City of Jacksonville, Florida

Goods and/or Services: Medical Examiner's Office

Recommend approval to amend the award with Perry-McCall Construction, Inc. for Amendment #5 to incorporate Exhibit F, which includes additional scope added to the new Medical Examiner's Office including additional electrical, mechanical, and voltage work along with reconciliation of the owner direct purchase materials. Total increase amount is $11,359.22, for a new NTE amount of $67,335,870.94.

Exhibit F

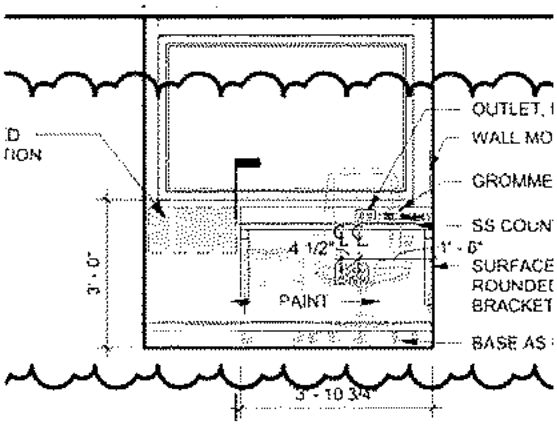
Modify existing solid surface countertop and slide RAKKS to the right $815.00
Allowing space for Transaction Drawer
Re-using existing material

Alternate:
Provide and install 12" door / drawer base cabinet $385.00

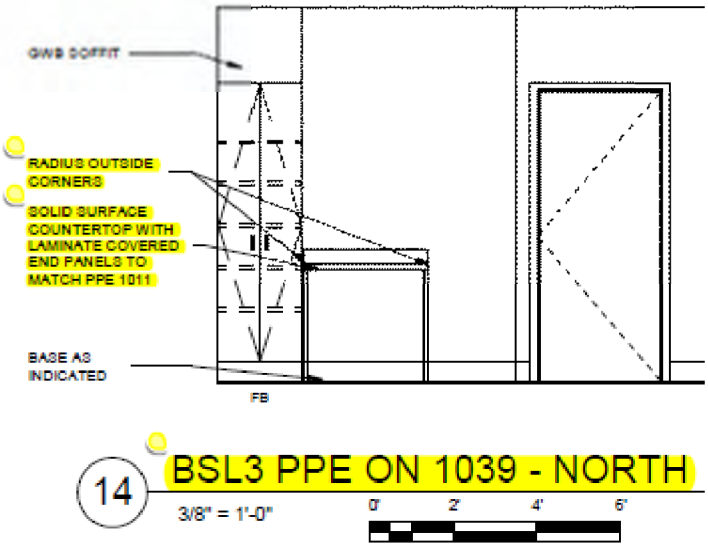
Provide and install added millwork in PPE 1039 to match what was previously provided
In room PPE 1011

- 24" Tall Cabinet
- 36"L x 10"D solid surface countertop and plam apron
- Plam support leg to floor
